**V1-CID-24-01**

**RE: The Point South - CD Package 3  
Rolesville Project Number CID-24-01  
Response to 1<sup>st</sup> Review Comments  
AWH20000**

### C5.01 – Plan and Profile

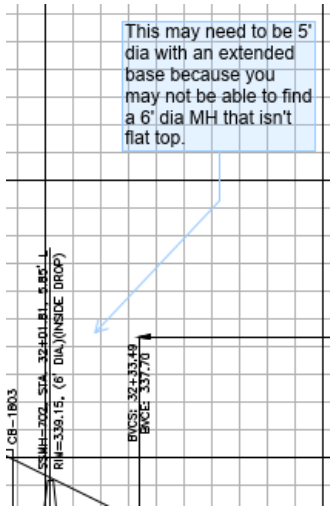
4. Please explore opportunities to change the sanitary design so that sewer does not have to be excessively deep within Reverie Way.

**McAdams Response: The sanitary sewer is deep in Reverie Way, but we were able to eliminate the preliminary sanitary sewer outfall through private property and tying to the Harris Creek Interceptor.**

C5.06 – Plan and Profile

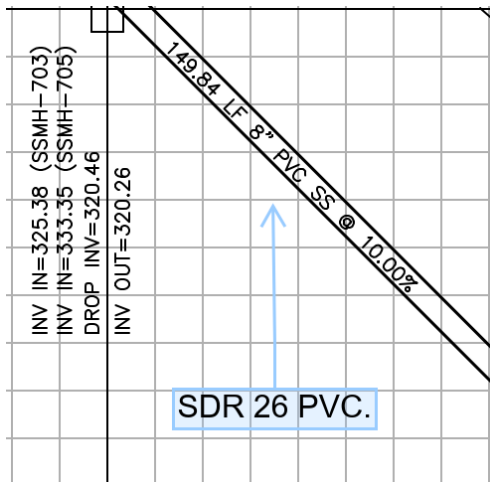
7. SDR 26 PVC.

**McAdams Response: We have corrected the pipe material to SDR 26.**

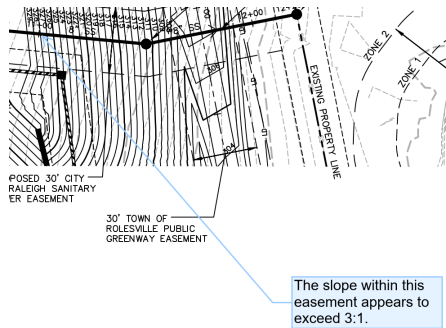
8. The slope within this easement appears to exceed 3:1.

**McAdams Response: The contours reflect a 3:1 slope.**

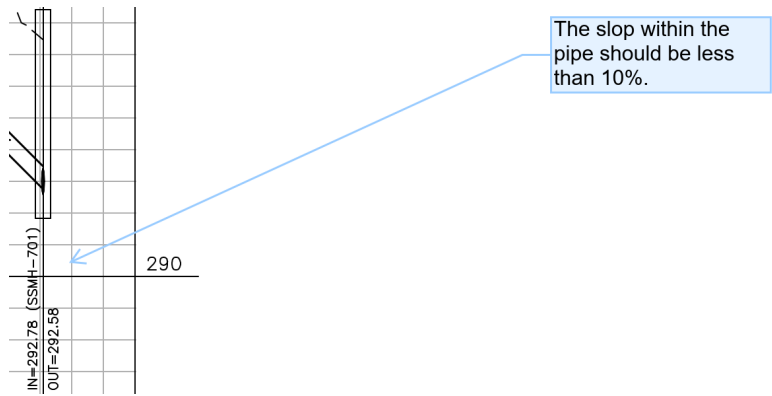
9. The slope within the pipe should be less than 10%.

**McAdams Response: The pipe slope has been revised be less than 10%.**
